Model: Adonis-P		Date: 31-Oct-99	No.: RG035001
Subject: Service Manual Corrections		Prepared by: K. Takagi	
From: Technical Service Dept., GTS Division			
Classification:	<input type="checkbox"/> Troubleshooting	<input type="checkbox"/> Part information	<input type="checkbox"/> Action required
	<input type="checkbox"/> Mechanical	<input type="checkbox"/> Electrical	<input checked="" type="checkbox"/> Service manual revision
	<input type="checkbox"/> Paper path	<input type="checkbox"/> Transmit/receive	<input type="checkbox"/> Retrofit information
	<input type="checkbox"/> Other ( )

Please make the following corrections in your Adonis-P service manual.

Model: Adonis-P		Date: 31-Jan-00	No.: RG035002
Subject: Service Manual Correction		Prepared by: K. Takagi	
From: Technical Service Dept., GTS Division			
Classification:	<input type="checkbox"/> Troubleshooting	<input type="checkbox"/> Part information	<input type="checkbox"/> Action required
	<input type="checkbox"/> Mechanical	<input type="checkbox"/> Electrical	<input checked="" type="checkbox"/> Service manual revision
	<input type="checkbox"/> Paper path	<input type="checkbox"/> Transmit/receive	<input type="checkbox"/> Retrofi

- **EtherTalk (AppleTalk) Network (Page 3-11)**

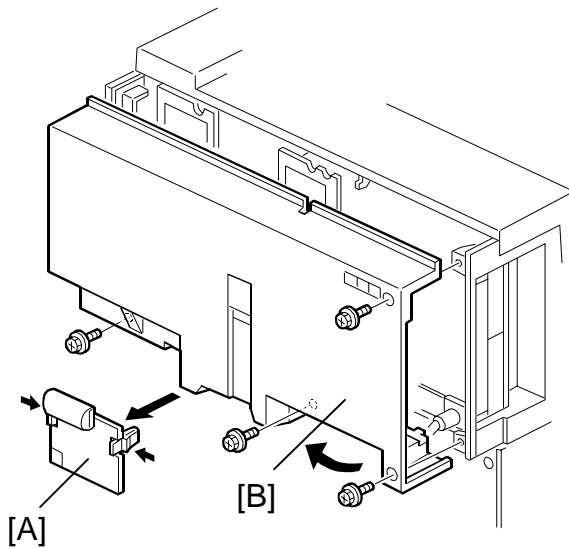
**Incorrect:**

Parameter	Default Setting	How to change the parameter
AppleTalk Enable/Disable	Enabled	MAP, web browser and telnet.
Printer Name	Plug&Play name ( <u>SP5-907</u> )	See Note.
Zone Name	Default zone	See Note.

**Correct:**

Parameter	Default Setting	How to change the parameter
AppleTalk Enable/Disable	Enabled	MAP, web browser and telnet.
Printer Name	Plug&Play name ( <u>SP2-21</u> )	See Note.
Zone Name	Default zone	See Note.

**4. REPLACEMENT AND ADJUSTMENT****• Upper Cover (Page 6-48)**

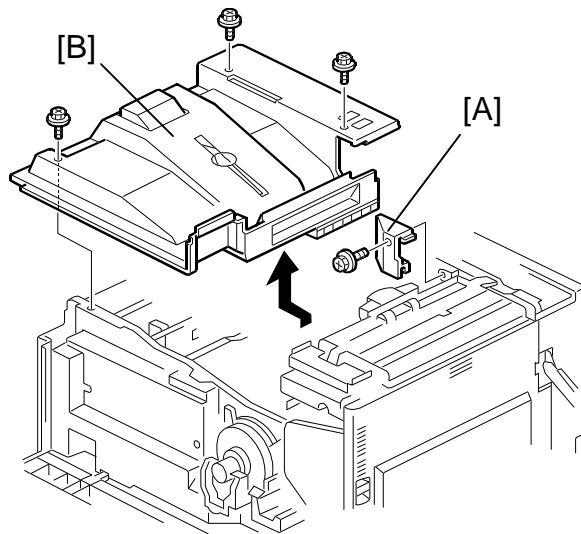
The wrong illustration is attached for the upper cover removal.

- **Printer Control Board and NIB (Page 6-50)**

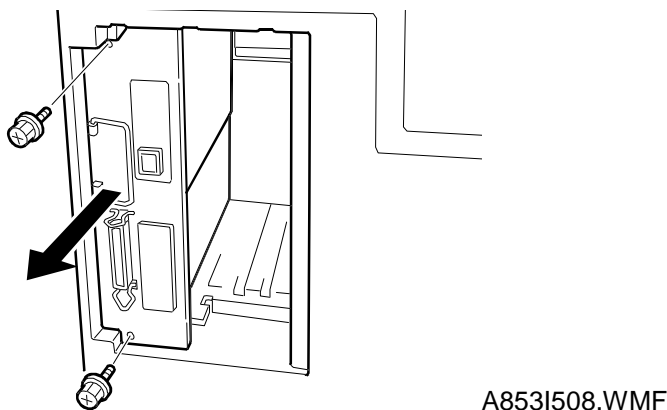
The wrong illustration was attached.

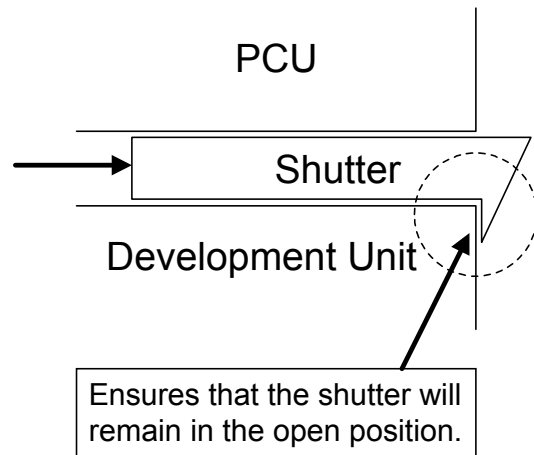
The toner supply shutter (parts catalog pg.27, index #28) returns to the closed position when the PCU unit (PCU and development unit) is put in the machine.

Normally, the shutter is not in the closed position when the machine is shipped out. However, if the technician removes the PCU unit from the machine and attempts to separate the PCU from the development unit, the shutter may return to the closed position.

1. The length of the pawl edge of the shutter was increased by 2.5 mm to prevent the shutter from returning to the closed position.
2. The tension spring (parts catalog pg.27, #27) included in the user maintenance kit was deleted.

If you should experience any future occurrences, remove the PCU unit from the machine, check the position of the shutter and return it to the open position if necessary (see the illustration below). After this, carefully place the unit back in the machine.

- **PHOTOCONDUCTOR UNIT (Page 2-16)**

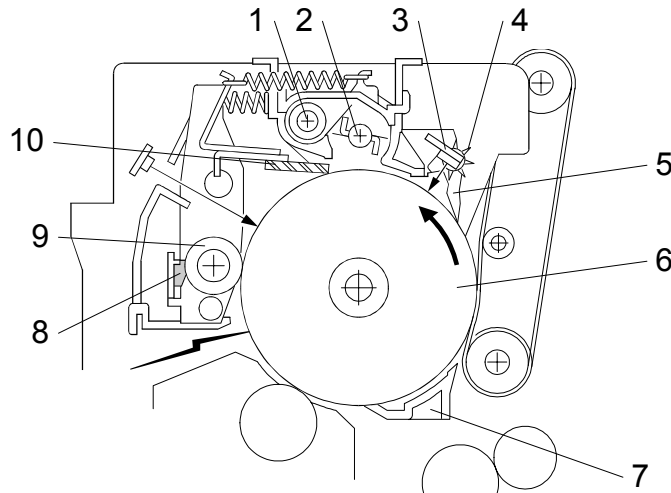
There were incorrect callout numbers for the overview illustration. Correct the illustration as follows:

- **PAPER REGISTRATION (Page 2-44)**

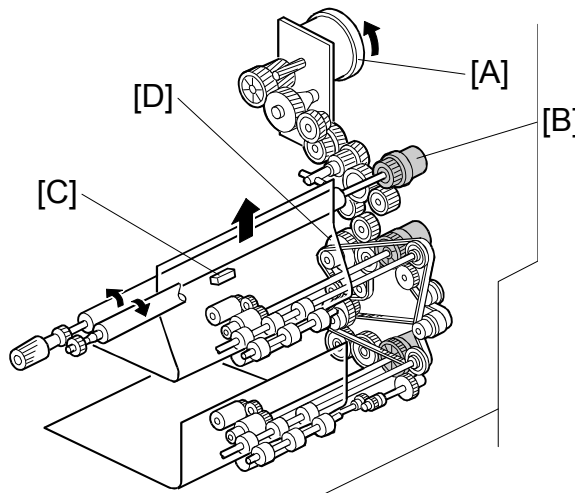
There was a missing callout and an incorrect callout in the illustration. Correct the illustration as follows:

- **PHOTOCONDUCTOR UNIT (PCU) AND DEVELOPMENT UNIT (Page 6-6)**

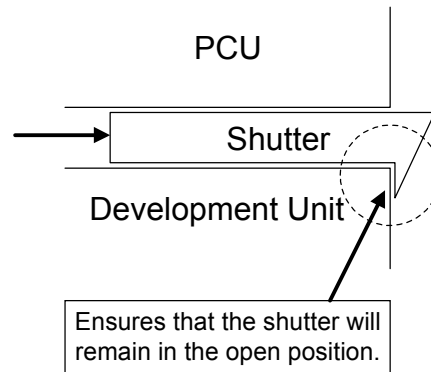
The following illustration and description should be added:

**NOTE:** Make sure that the toner supply shutter [C] is at the open position before reinstalling the unit.

### Copy Flash ROM (Sp1-3)

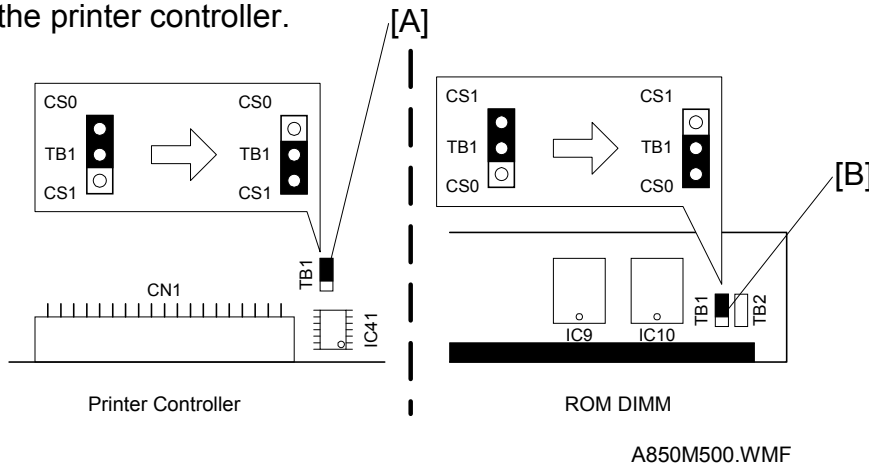
The following procedures should be added.

2. Change the position of the TB1 jumper [A] on the controller from CS0 to CS1.
  3. Change the position of the TB1 jumper [B] on the ROM DIMM that contains the controller firmware from CS1 to CS0.
  4. Install the ROM DIMM on the controller.
- CAUTION:** Make sure to install the correct ROM DIMM in the PS SIMM connector.
